# Response to Technical Review Comments

## Clear River Energy Center and Burrillville Interconnection Project

Application No. 17-0079

**Re: Clear River Energy Center, LLC  
Burrillville RI  
Application No. 17-0079**

SHEET  
01C804  
16 OF 18

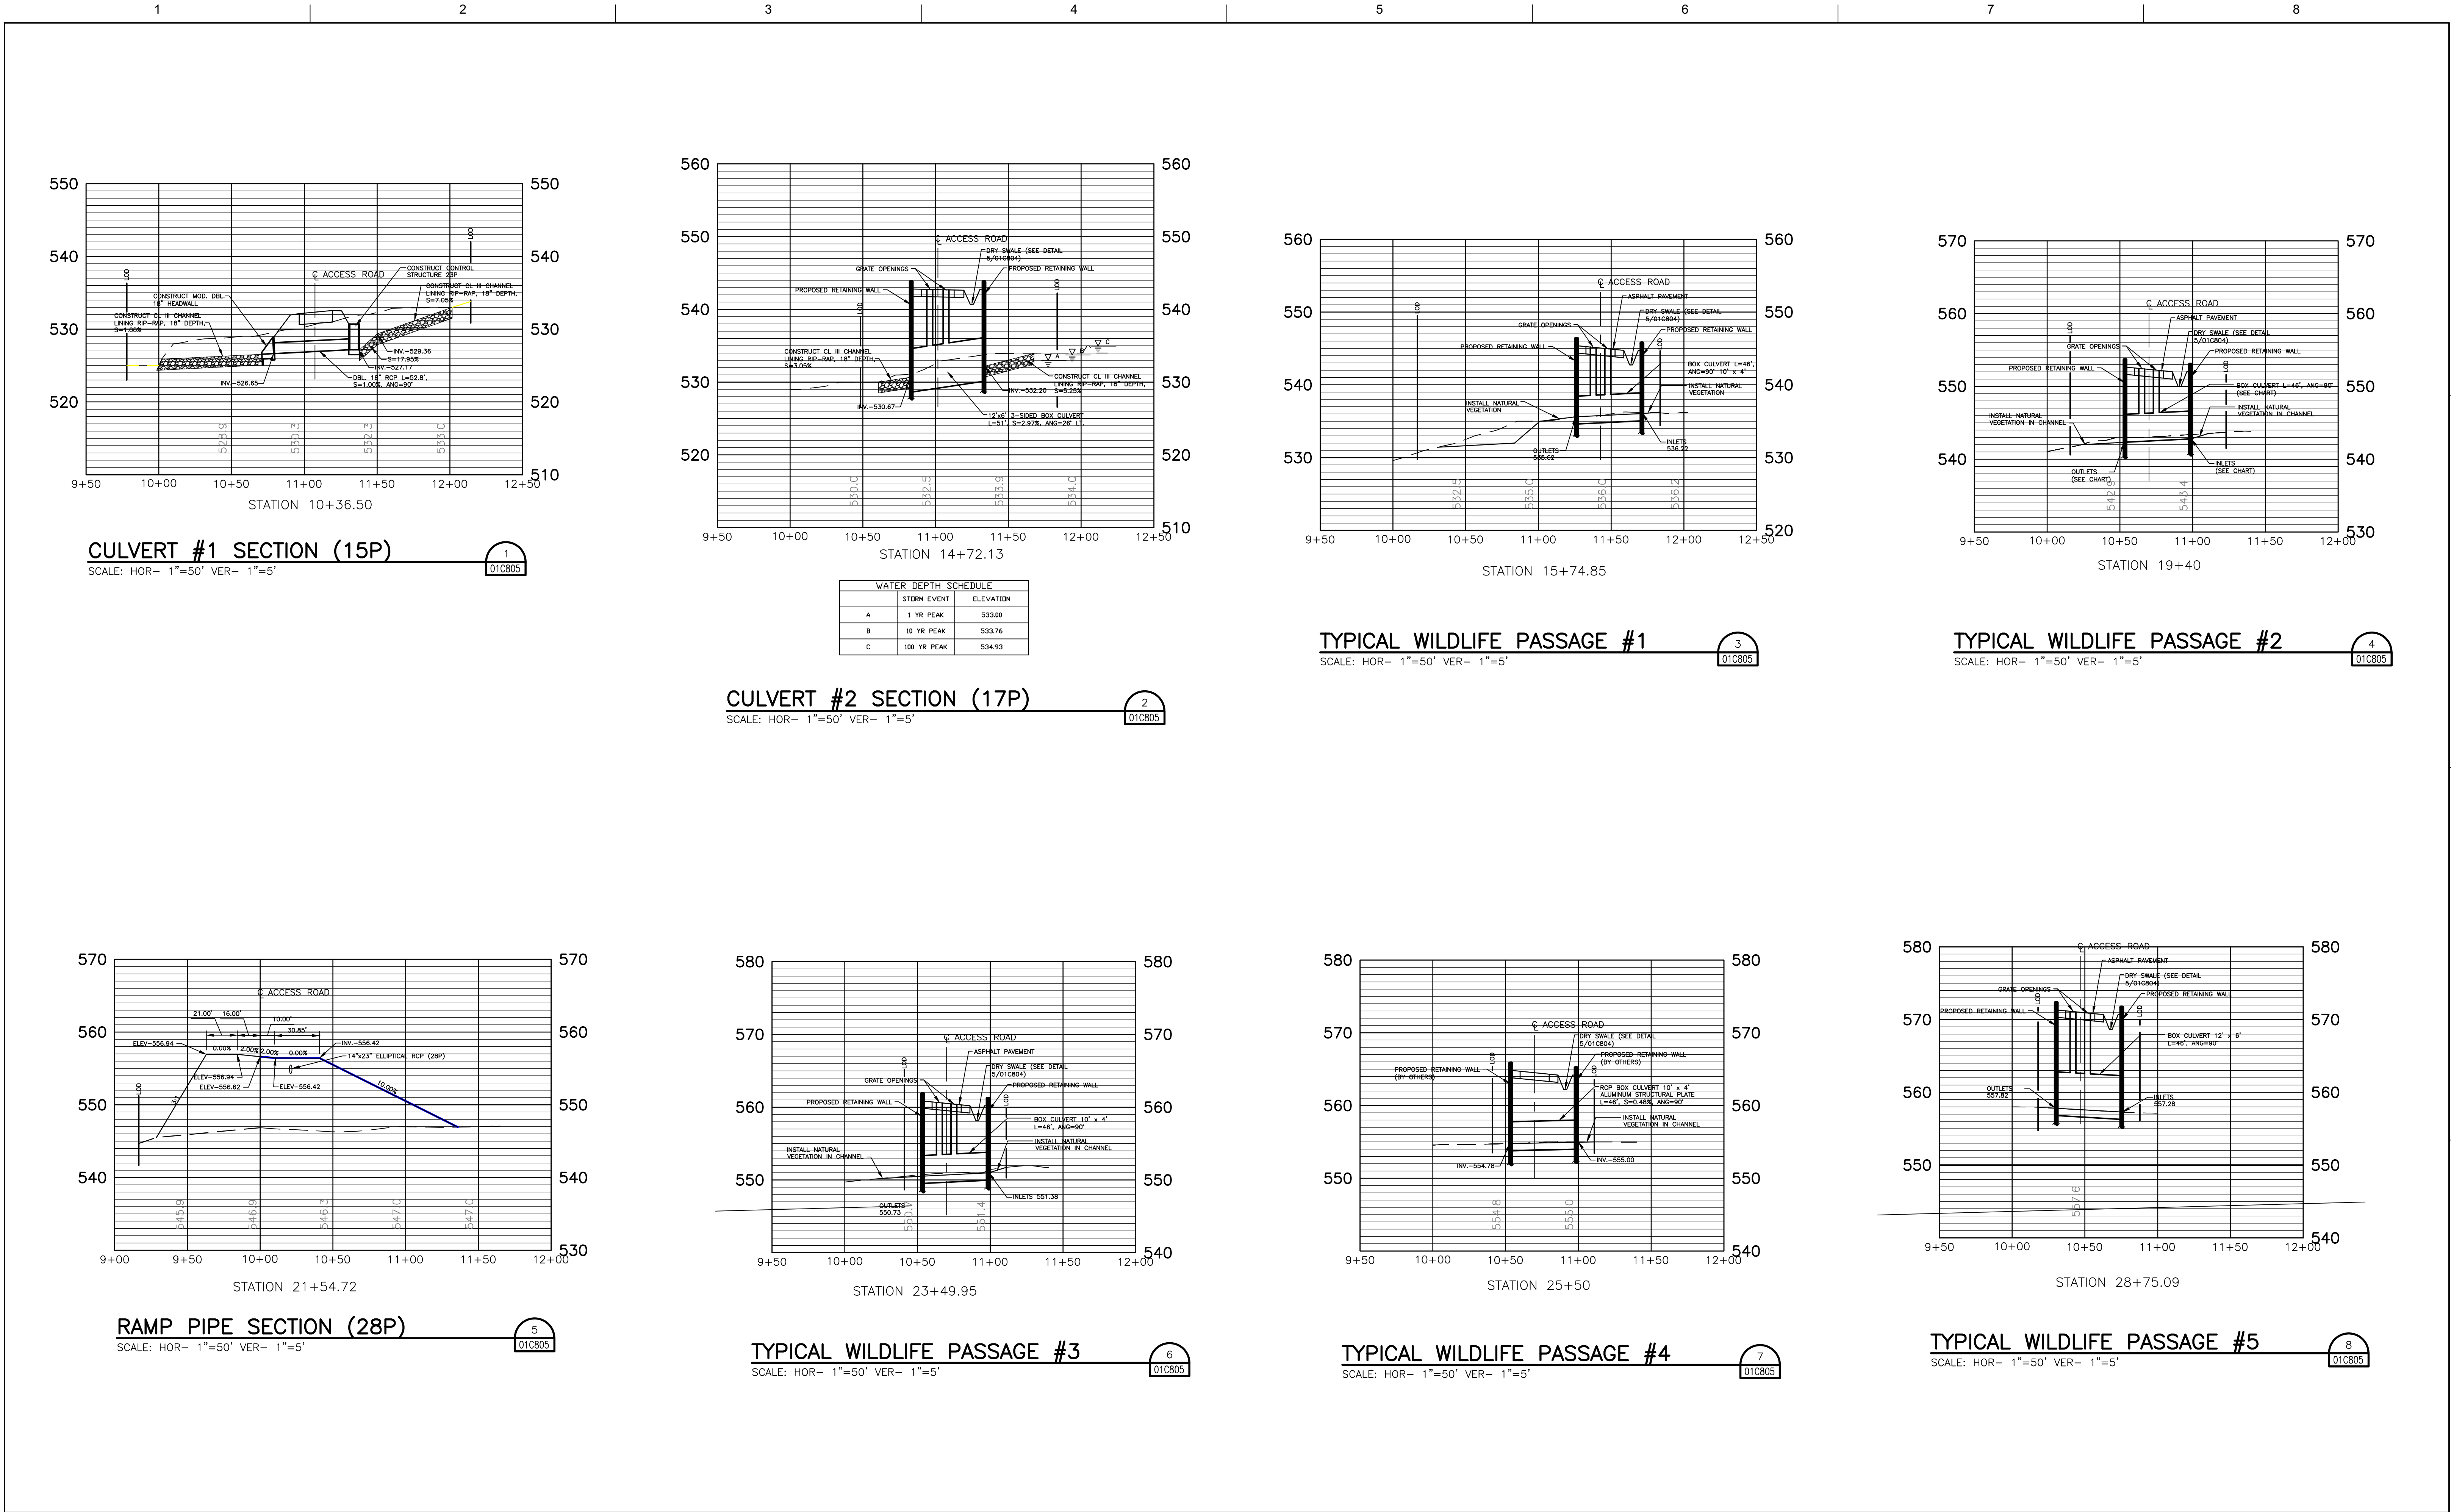
**Response:** Details 6/01C804 and 4/01C804 (both on Sheet 16 of 18 - see Exhibit 1 Volume I) now show a gravel trench with pea gravel wrapped in filter fabric and a check dam before the

**Response:** A trash rack was added to the control structure for Detention Pond 2 which are depicted on Details 1/01C805, 2/01C805, and 3/01C805 on Sheet 16 of 18. The detail of the trash rack is shown on Detail 7/01C805 on Sheet 16 of 18 (see Exhibit 1 Volume I).

**Response:** The principal spillway for Detention Pond 1 has a fence around it as shown on Sheets 6 and 10 of the drawing set. The principal spillway for Detention Pond 2 has a trash rack on top (see Detail 3/01C804 on Sheet 16 of 18) which will prevent any unauthorized access (Exhibit 1 Volume I).
